ORIGINATION FORM

Proposed Revisions to a Standard Plans Index (Please provide all information — Incomplete forms will be returned)

Index Number: 450-511

Index Title: Bearing Plates (Type 1) -Prestressed Florida-I and
AASHTO Type II Beams**Summary of the changes:**

LAST REVISION 07/01/14	REVISION	DESCRIPTION:	 FY 2020-21 STANDARD PLANS	BEARING PLATES (TYPE 1) - PRESTRESSED FLORIDA-I AND AASHTO TYPE II BEAMS	INDEX 450-511	SHEET 2 of 2
---------------------------	----------	--------------	--	---	------------------	-----------------

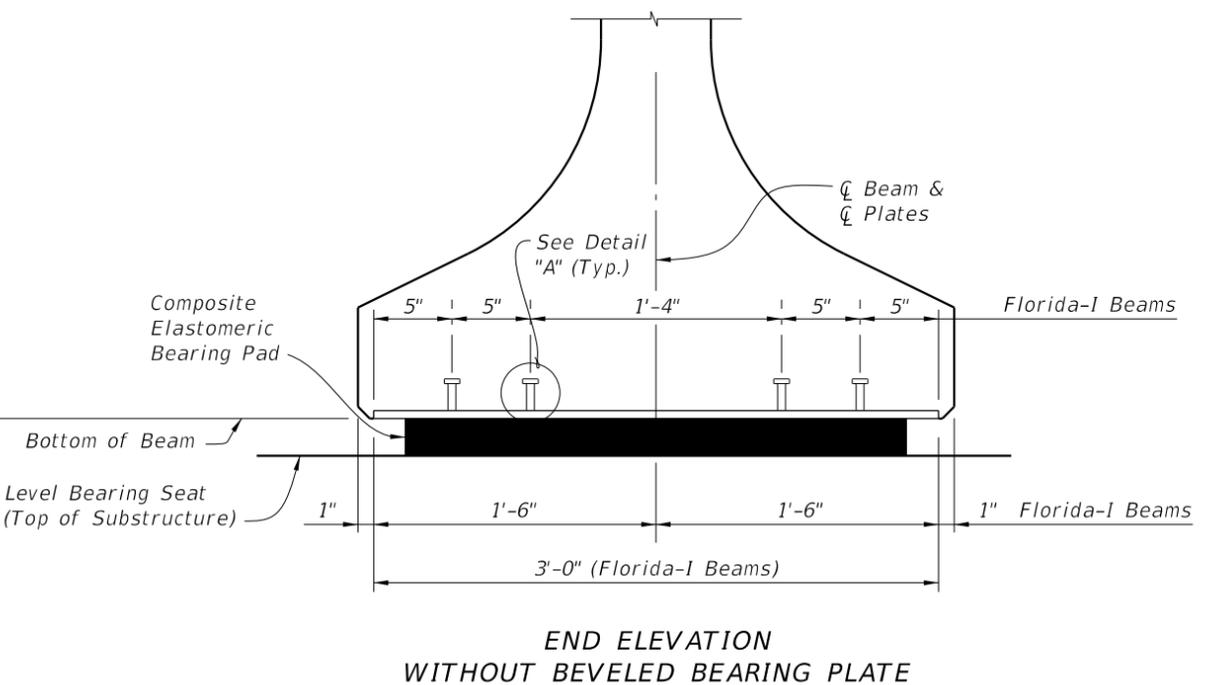
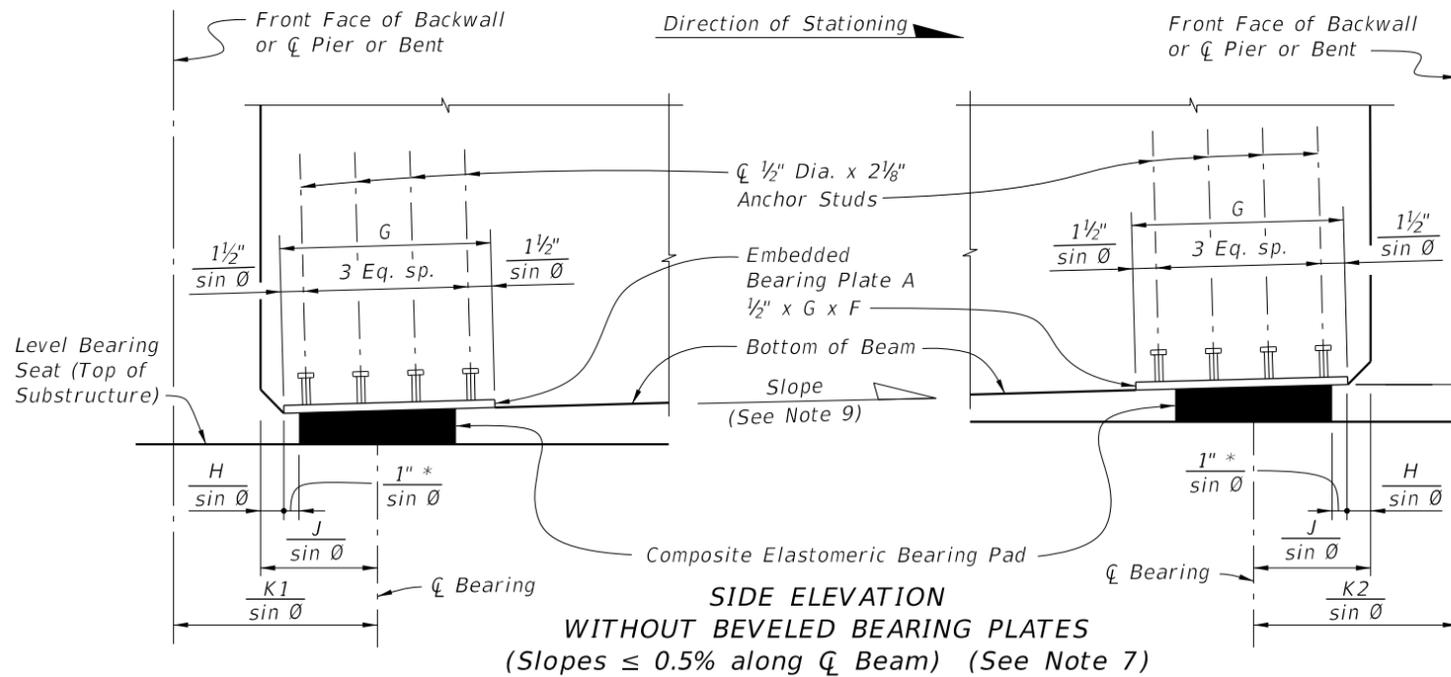
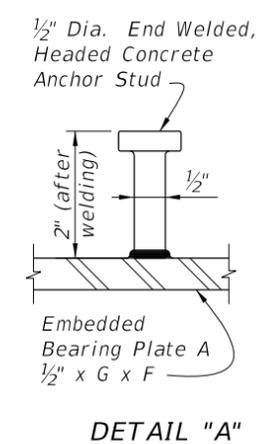
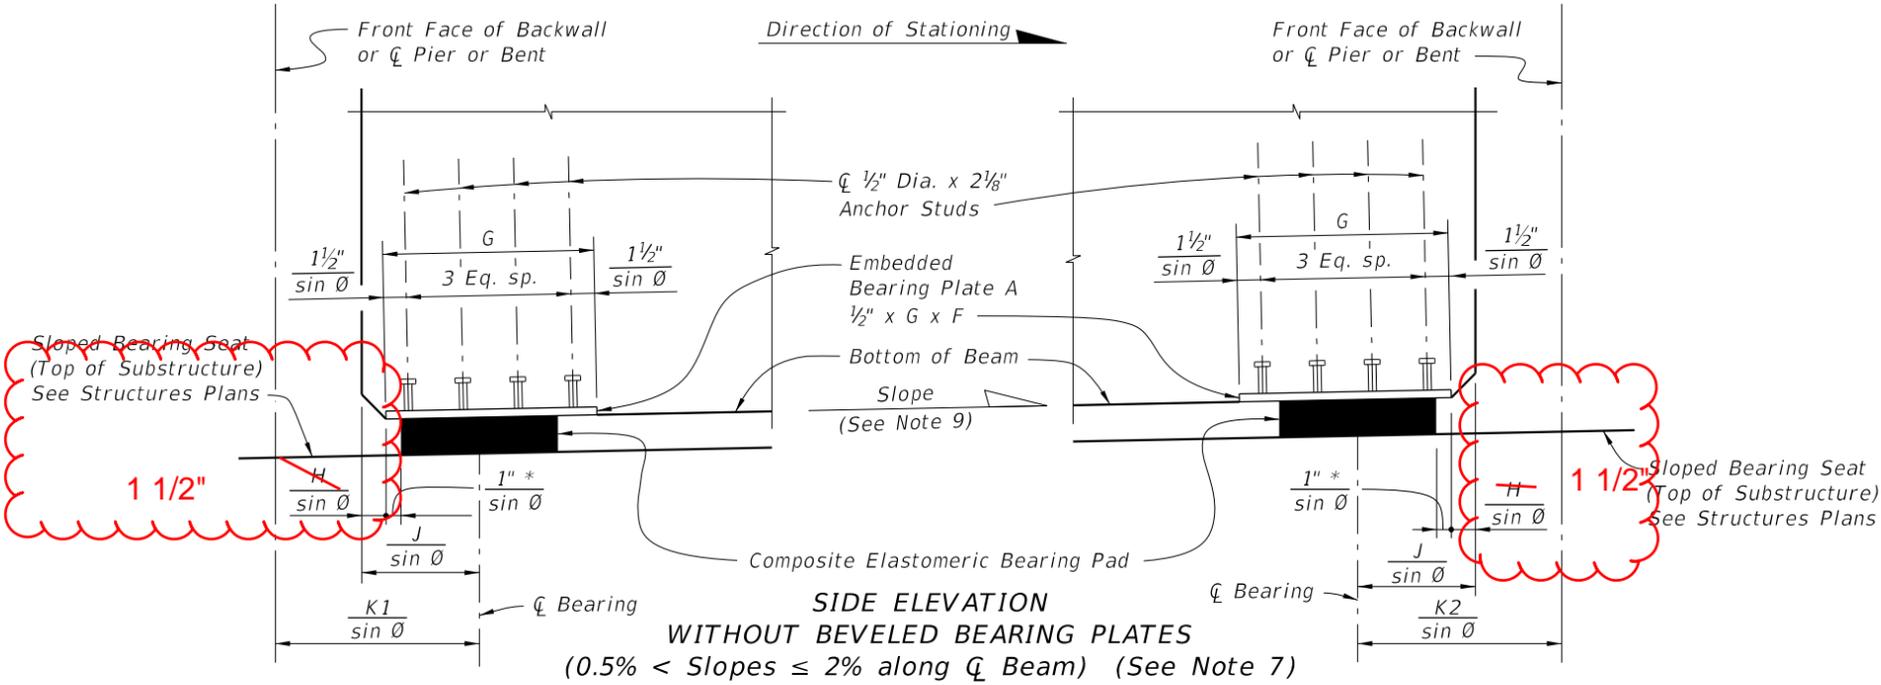
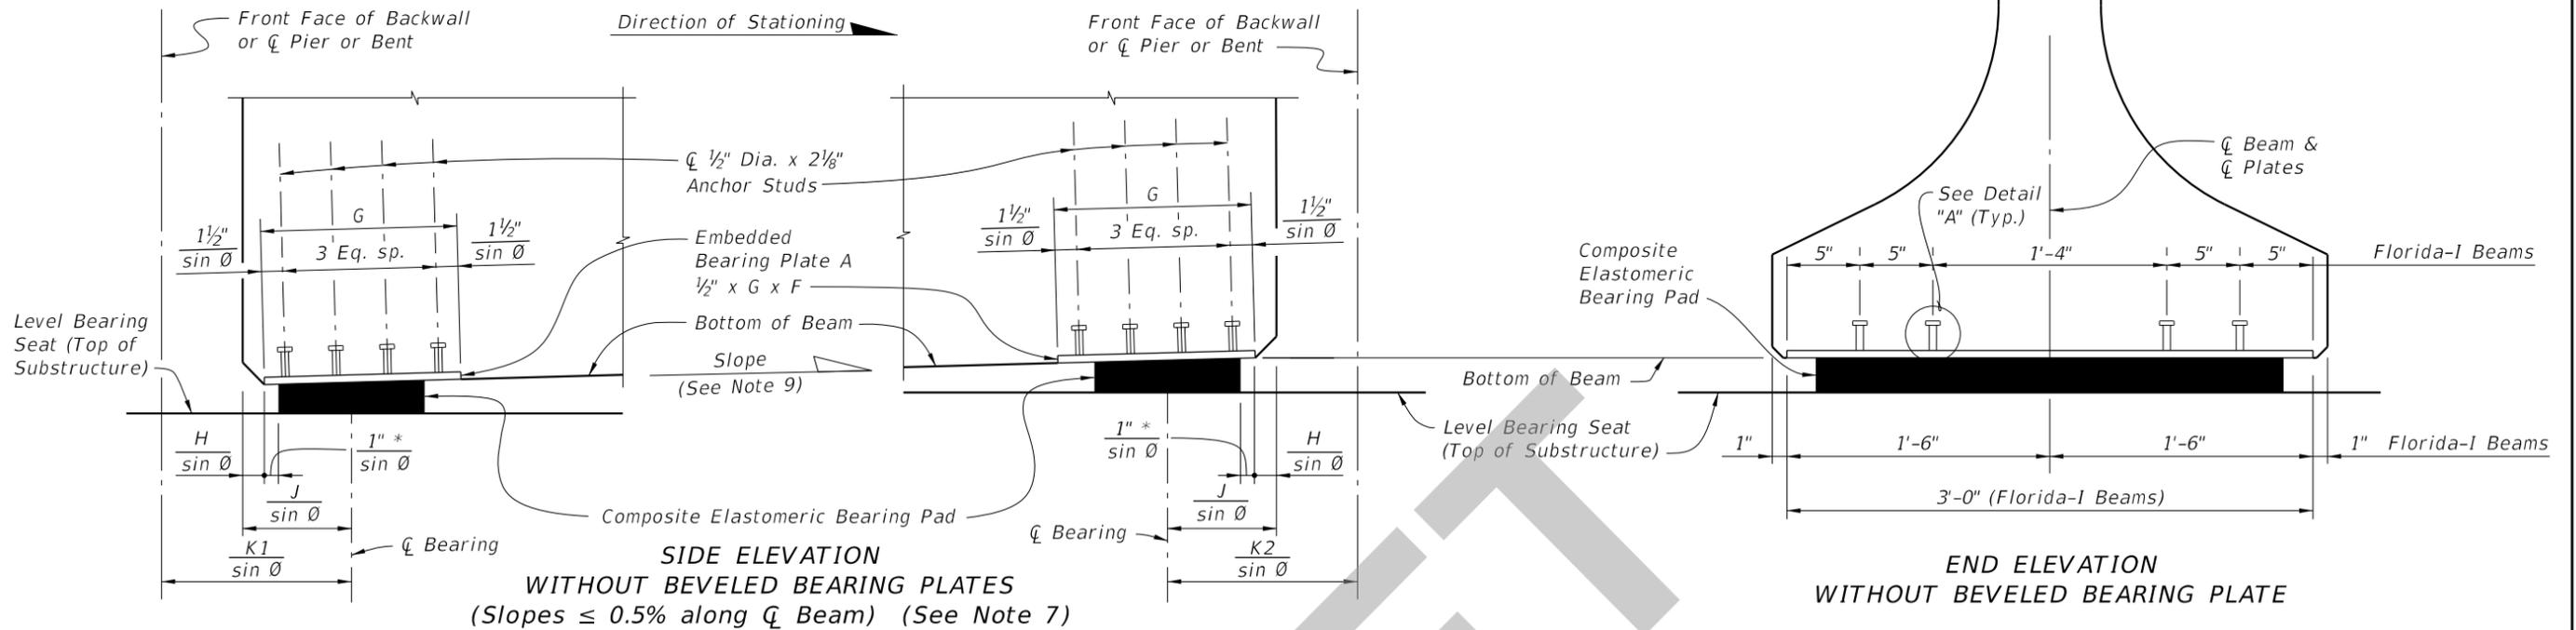
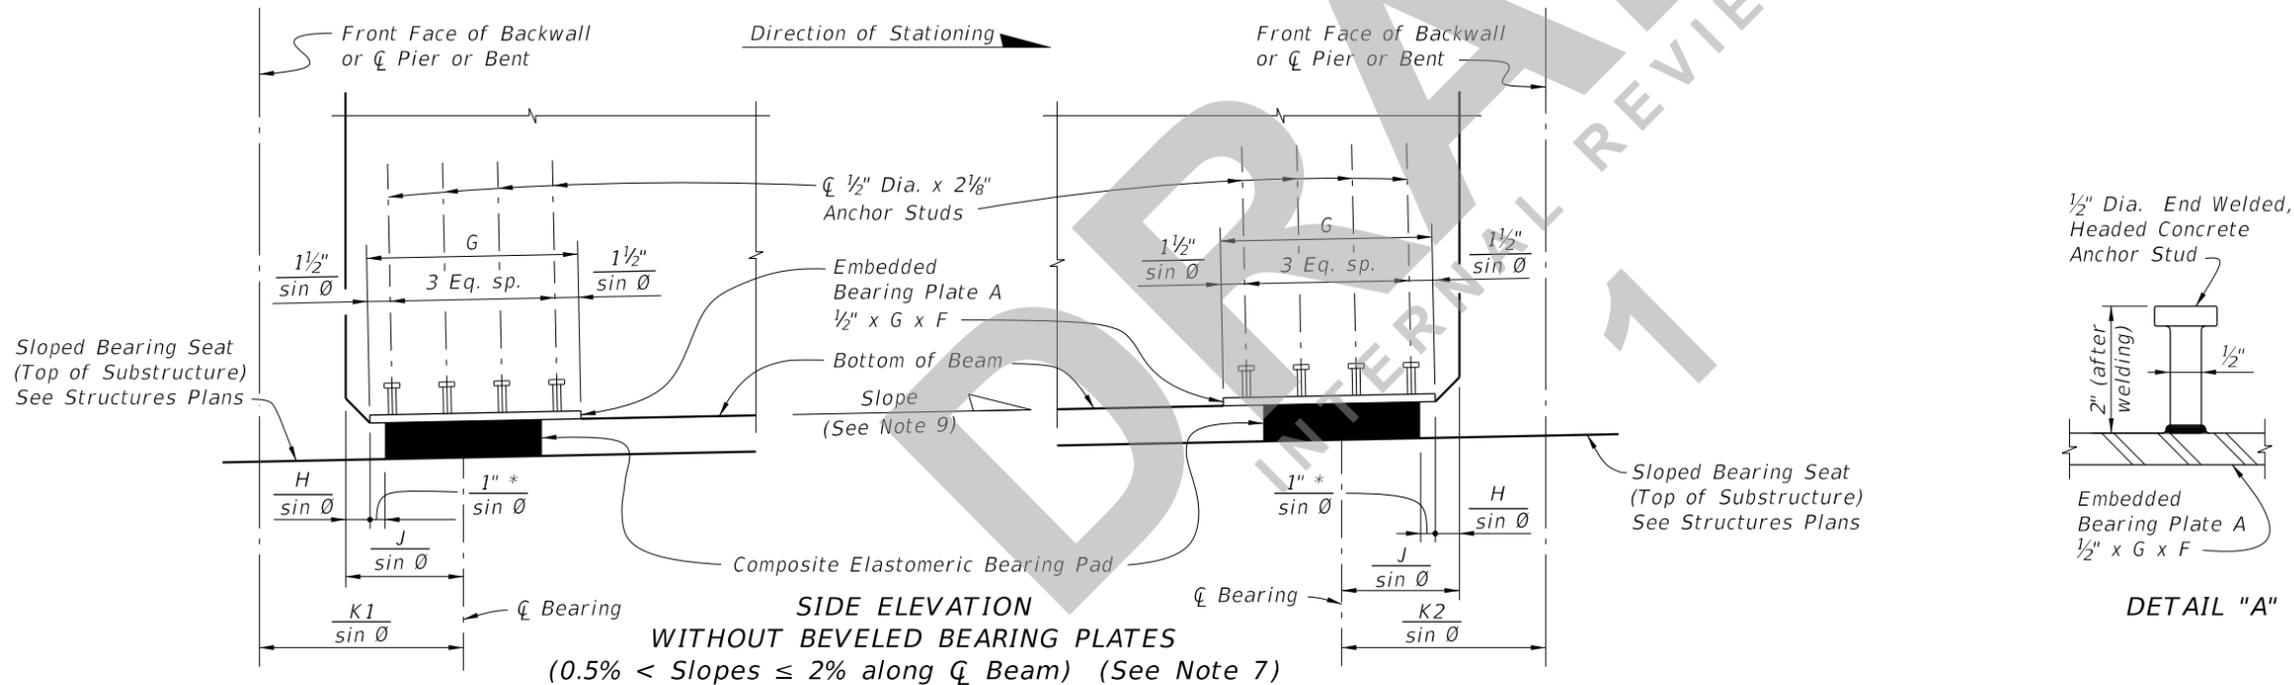
Delete dimension H (replace with number).

H as shown is a hard dimension that does not change; therefore change it to 1 1/2".

CROSS REFERENCE:
See Sheet 1 for ~~dimension H~~ and Notes.
